URGENT FIELD SAFETY NOTICE**bellavista™ Ventilators****Ceasing of Ventilation with Technical Failure Alarm 305
for Field Safety Corrective Action FSCA-2021-001**

FSN Ref: FSCA-2021-001-FSN-1

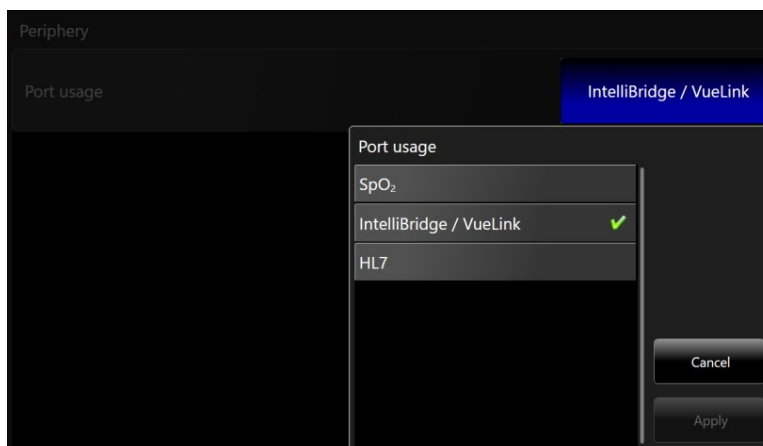
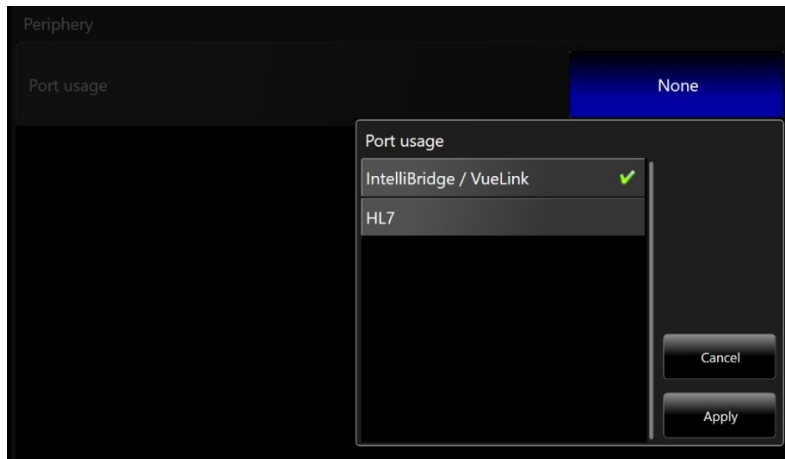
1. Open **Configuration Assist**.

2. Select the **Periphery** settings.

3. Ensure that **Port usage** is **NOT** configured to "HL7".

For 13.3" devices, select "IntelliBridge / VueLink" or "SpO₂".

For 17.3" devices, select "IntelliBridge / VueLink".
